PLANNING DEPARTMENT STAFF REPORT AND FINDINGS

ROLLING MEADOWS MINOR PARTITION – PRELIMINARY PARTITION APPROVAL (File MP 23–14)

Preliminary Partition Plan Map

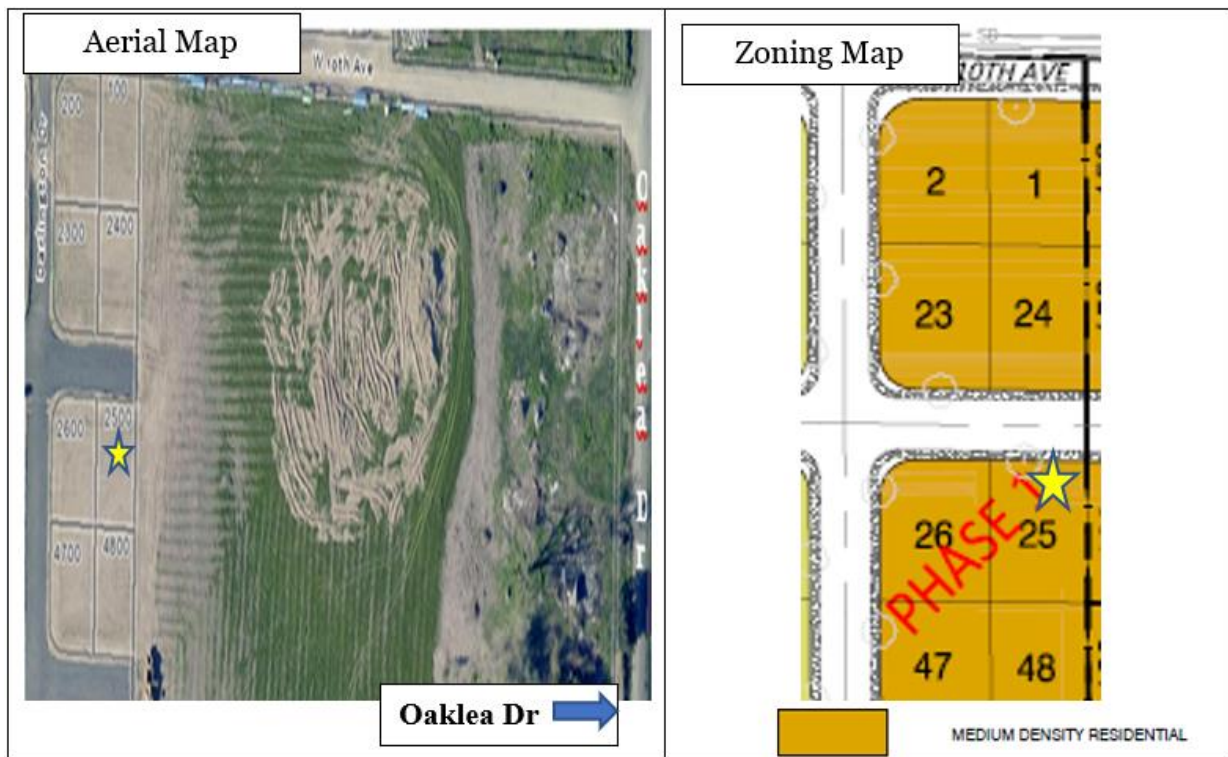
The 34+ foot lot widths and the sub-3,500 square foot minimum lot size of the proposed minor partitions do not meet the existing minimum width standard of 50 feet or minimum 3,500 square foot standard of 17.15.030.E. However, the applicant has proposed a major modification to the PUD (PUD 23-24) that would reduce the minimum lot size to 3,000 square feet, increase the minimum lot depth to 90 feet, and reduce the minimum lot width to 34 feet. If this modification is not first approved by the Planning Commission then this minor partition cannot be approved.

Finding 3: Section 17.05.030.B of the JCMC was changed to allow attached single-family dwellings that have a minimum lot area of 3,500 square feet and Parcel 1 of this minor partition does not comply with this standard. Also, the parcels do not meet the minimum lot width of 50 feet.

Finding 9: The preliminary plan has the date, north point and scale of the drawing. The demensions of the property are adequately identified as adjacent tax lots are identified and numberd. The legal description of the property is Lot 25, Rolling Meadows PUD Phase 1. Neither the preliminary partition plan nor the supplemental materials identify the assessor's account number (Act #1914516).

Finding 10: The name and address of the owner/partitioner is present on the preliminary plan and its telephone number. However, the telephone number is included on the application form. The applicant's representative's name and address is listed on the preliminary plan as is Marcus Cross, the applicant's surveyor.

Finding 14: The preliminary plan shows the location of two water easements and aa 10' wide public utility easement. These easements were dedicated to the City as part of the approval of Phase 1 of the Rolling Meadows Subdivision.

Finding 16: The Superintendent of Public Works reviewed the application. He pointed out that each lot will need its own sewer connection as the units cannot share a sewer lateral. Also, each unit must have its own water meter. A maintenance agreement will be required for things like the shared roof and fences.

The proposed parcels are less than 35 feet wide, are less than 3,500 square feet in size, and have less than 60 feet of frontage on 10th Avenue. The Planning Commission will have to approve the major modification to those standards for the minor partition to be approved.

Finding 39: The proposed parcels are large enough for their intended residential use for attached single-family dwellings. However, because the lot widths will be 34 feet, it is recommended that the parcels share a driveway when developed.

Condition of Approval #1: The final plat must show all easements. All easements must be recorded and the public utility easements dedicated to the City prior to final plat approval.

Condition of Approval #2: Because of the narrow width of the lots, the parcels must have a shared driveway when developed.
